Access Compliance Report

Public Rights-of-Way

(Curb Ramps)

Intersection ID: 42985	Main Street: BESSANT_CT	Cross Street: CHOWNING_TAVERN_LN	Location: N
ADA ID: DC7A3B8A782F	Ramp Type: PerpDiag	Initial Pass/Fail: Fail	Overall Compliance: No
		Severity Score: 46.25

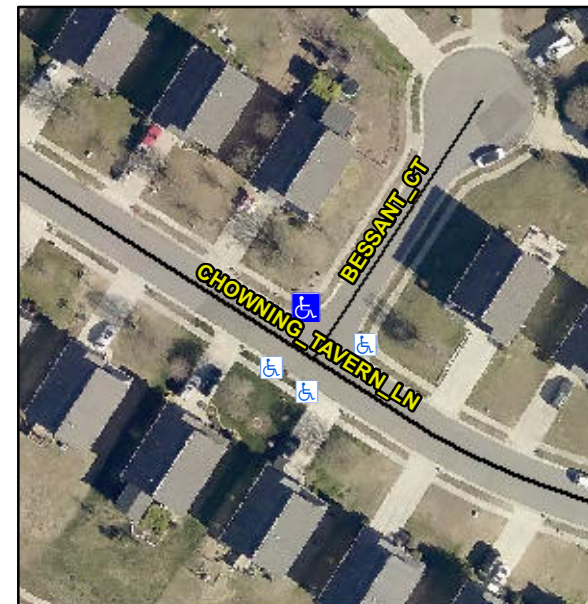
Not Found, R304.5.1, R304.2.2, R304.5.3

Compliance	Description	Data	Compliance	Description	Data
N/A	Ramp Length (in)	48.0	No	Ramp Slope (%)	10.5
No	Ramp Width (in)	43.0	No	Ramp XSlope (%)	9.1
N/A	Flare Type LT	N/A	N/A	Flare Type RT	N/A
N/A	Flare Slope LT (%)	N/A	N/A	Flare Slope RT (%)	N/A
N/A	Flare Traversable LT?	N/A	N/A	Flare Traversable RT?	N/A
N/A	Landing Length (in)	N/A	N/A	DWS Provided?	N/A
N/A	Landing Width (in)	N/A	N/A	DWS Contrast?	N/A
N/A	Landing Slope (%)	N/A	N/A	DWS Length (in)	N/A
N/A	Landing X Slope (%)	N/A	N/A	DWS Full Width?	N/A
N/A	Landing Curb? (Y/N)	N/A	N/A	DWS Offset (in)	N/A
N/A	Shared Landing?	N/A			
N/A	Gutter Ponding?	N/A	N/A	Gutter Slope (%)	N/A
N/A	Gutter Lip Ht (in)	N/A	N/A	Gutter X Slope (%)	N/A
N/A	Painted X Walk1?	No	N/A	Painted X Walk2?	No
	X Walk 1 Direction	To SW		X Walk 2 Direction	To SE
N/A	X Walk 1 Width (in)	N/A	N/A	X Walk 2 Width (in)	N/A
	X Walk 1 Slope (%)	3.3		X Walk 2 Slope (%)	2.4
	X Walk 1 X Slope (%)	3.4		X Walk 2 X Slope (%)	6.4

Remove & Replace Curb Ramp With Two New Directional Ramps or Equivalent.
